Village of Chenequa Plan Commission  
Monday, June 9, 2025 at 6:00 p.m.  
31275 W. County Road K, Chenequa, WI 53029

## STAFF REVIEW

**Subject:** Site Plan Review

**Project Description:** Proposed Accessory Structure

Landscape Plan  
John Klatt, PLA, ASLA  
Chris Miracle, PLA, ASLA  
Sheet Number: 1/2  
Date: 5.15.2025

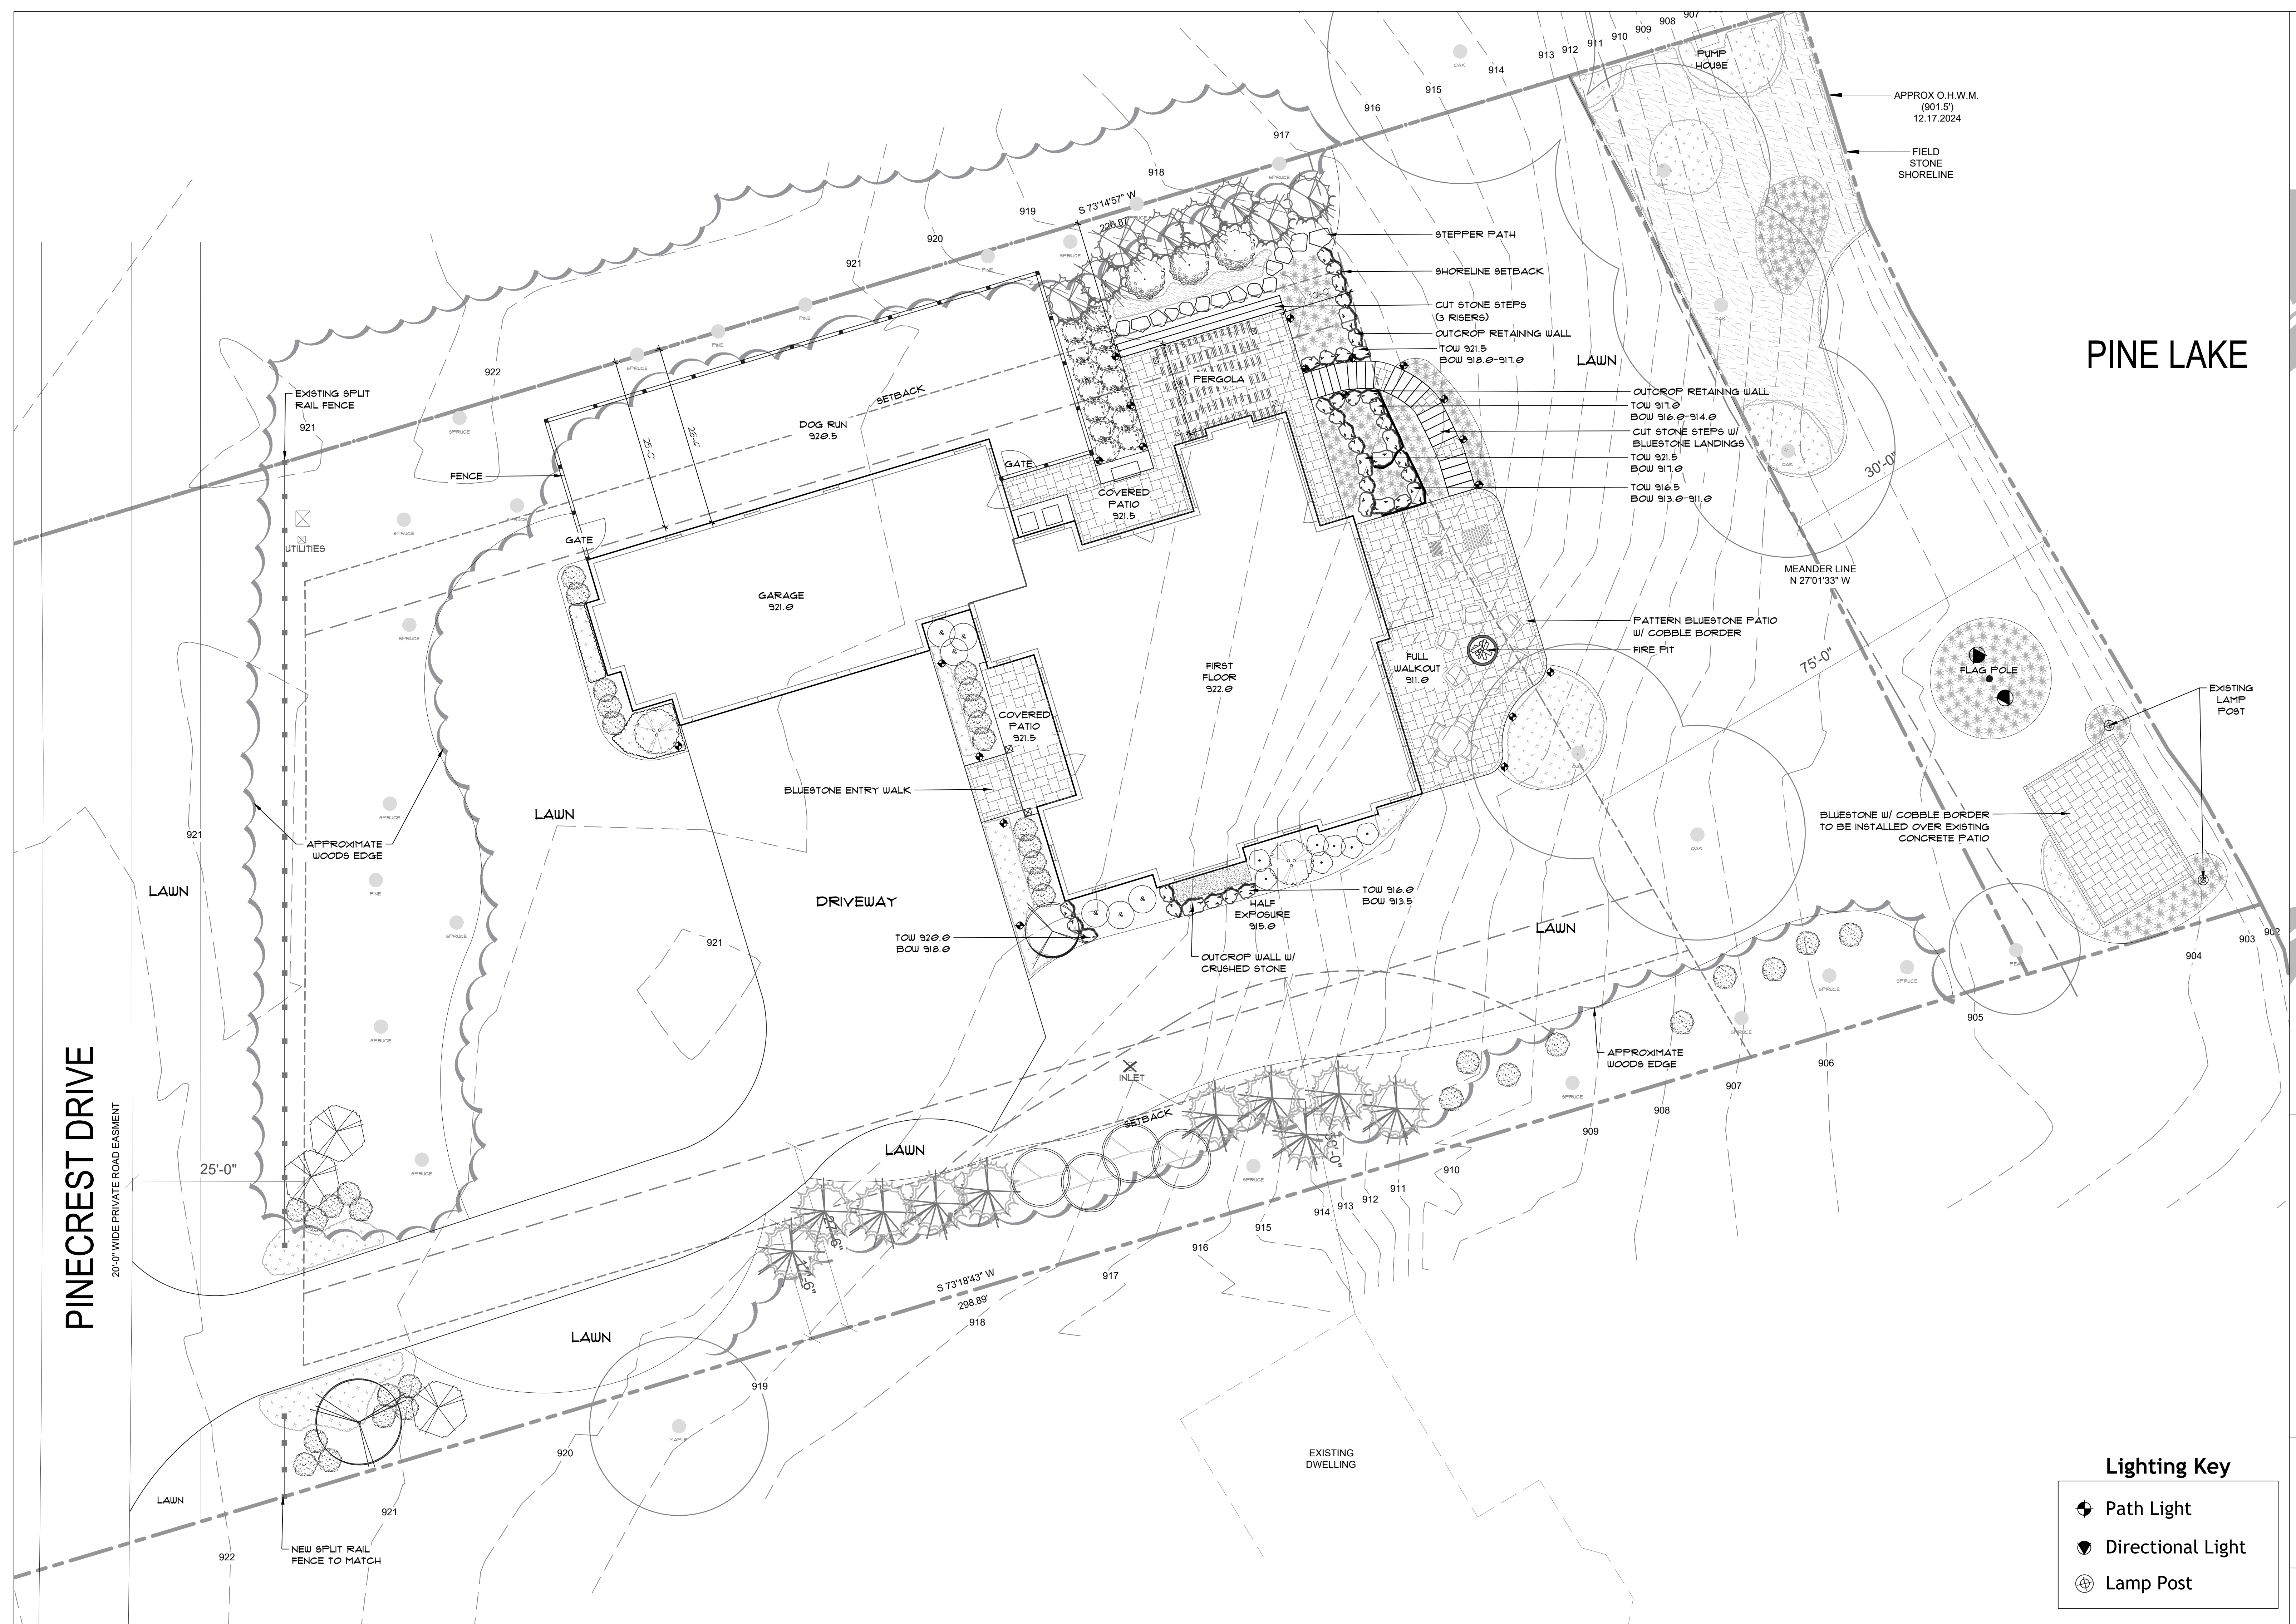
- b. These patios are proposed to be constructed of bluestone with a cobble border.
  - c. Location of these patios can be found on the provided landscape and lighting plan

- c. Stairs
    - i. The landscape plan proposes a single set of stairs that connect the patio on the north side of the dwelling with the patio on the lakeside of the dwelling.

- ii. The applicants seek permission to place a bluestone paver on top of the existing patio to match the other proposed patios,
    - iii. This modification would not result in an increase in patio footprint.

2. Proposed Landscape Lighting
    - a. The landscape plan also proposes 20 fully shielded pathway lights around the property.
      - i. A spec sheet for the proposed landscape light is provided in the packet
